Turbo HD DVR V3.4.2 Release Notes (2016-1-21)

Reason of Upgrade

Firmware Updates

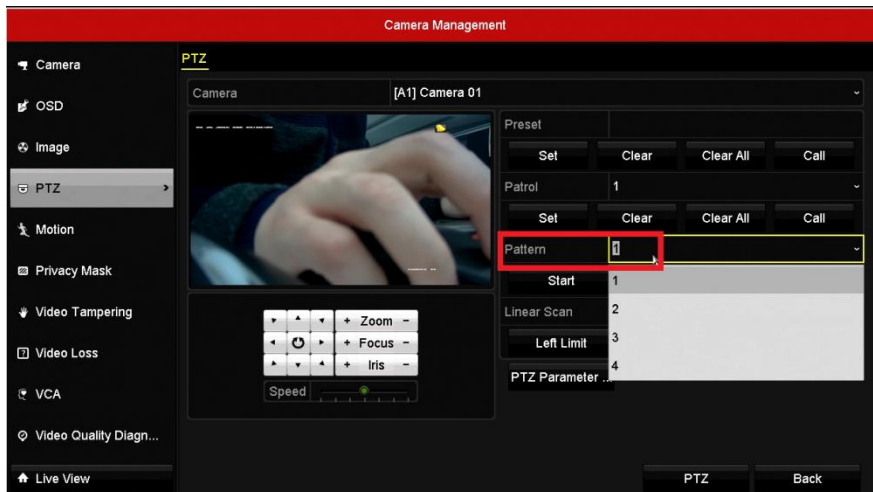
- i. Newly support 4K (8MP) resolution HDMI output for DS-7216HQHI-F1/N and DS-7216HQHI-F2/N.
- ii. Newly support **Enhanced TVI 720P Compatibility** function. When this function is enable,
 - a) It will increase the transmission distance of 720p signal input;
 - b) It will support third-party TVI 720P camera access;

NOTE: TVI 1080P camera can't be connected if this function is enable.

- iii. Newly support 4 patterns if choosing PTZ Protocol as **HIKVISION-C(Coaxitron)** , which used to be only 1.

- iv. The lower and upper case letter of soft keyboard both use the same case: upper case. In version 3.4.0 lower case and upper case is distinguished.

- v. Max numbers supported for video search decrease from 4000 to 2000.
